RE: Urban Lot Split-Preliminary Parcel Map No.:
ADM-2025-2340-PMUL-HCA
Address: 15159 W Morrison St
Community Plan: Van Nuys – North Sherman
Oaks
Zone: R1-1-RIO
Council District: 4 - Raman

LETTER OF COMPLIANCE – Ministerial Review of SB 9 Urban Lot Split

PRELIMINARY PARCEL MAP LA NO.
SITE ADDRESS: 15159 MORRISON ST, SHERMAN OAKS, CA 91403

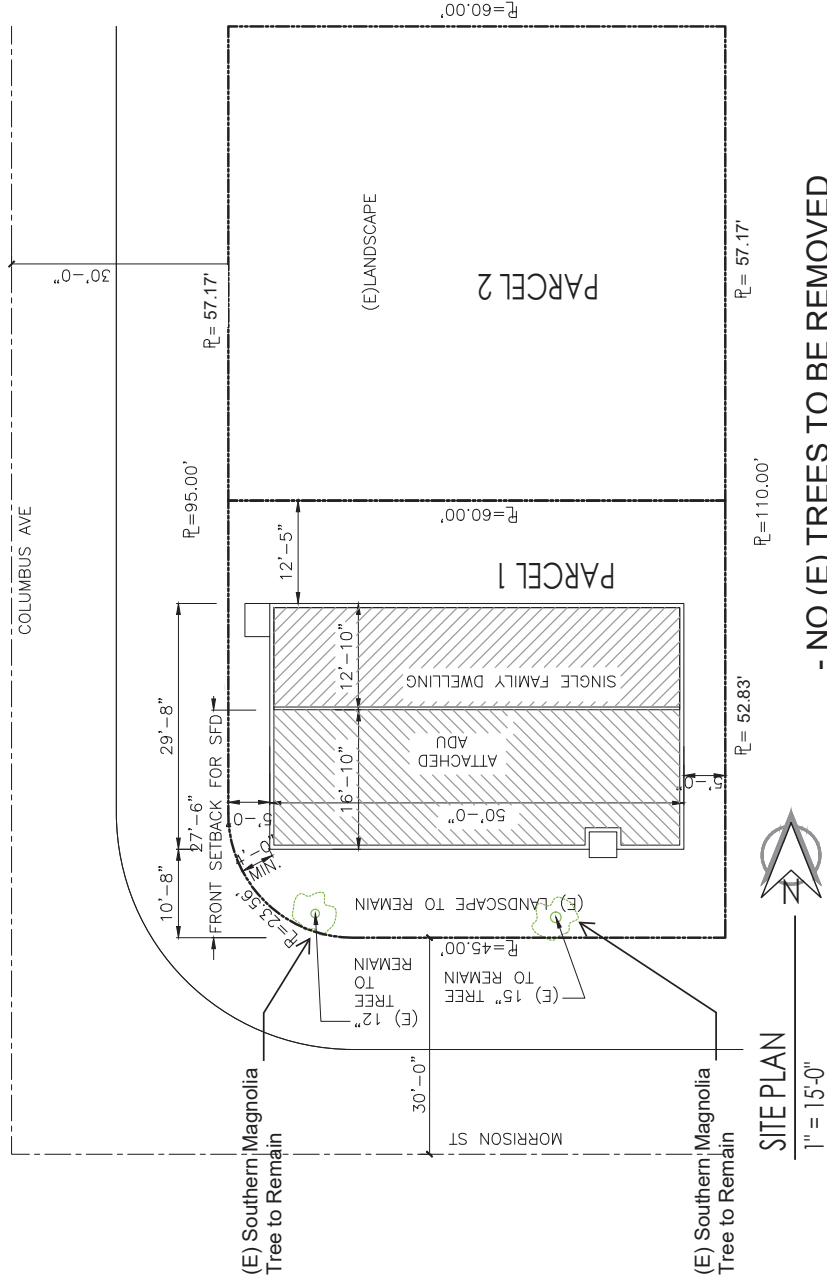
- a. The Proposed Parcel 1 does not comply with the allowable Residential Floor Area (RFA) for the R1 zone. The existing RFA for the structure per Permit 23014-10000-04319 is 1404 SF. The allowable RFA for the R1 zone is 45% of the lot area. Show compliance with the allowable Residential Floor Area requirement or obtain approval from the Advisory Agency to approve the deviations from the Zoning code.

On the May 6, 2025, tentative parcel map Lot A was proposed to be 3,116.6 square feet, or 47.6 percent of the existing lot, and Lot B was proposed to be 3,435, or 52.4 percent of the existing lot. As proposed, this meets the requirement of SB9, however per Condition 5.a from the Department of Building and Safety, the existing structure will not meet the .45:1 residential floor area limit of the R1-1 zone. Therefore, the applicant modified the lot line in order to provide 3,121.6 square feet of lot area to meet the residential floor area requirements. This modification would represent 47.6% of the existing lot and still qualify for processing under SB9. The resulting Parcel B is proposed for 3,430 square feet which represents 52.4 percent of the existing lot. This is reflected in the revised parcel map stamp dated July 10, 2025.

AREA:
TOTAL AREA: 6,551.6 (sq ft)
PARCEL 1: 3,121.6 SF
PARCEL 2: 3,430 SF
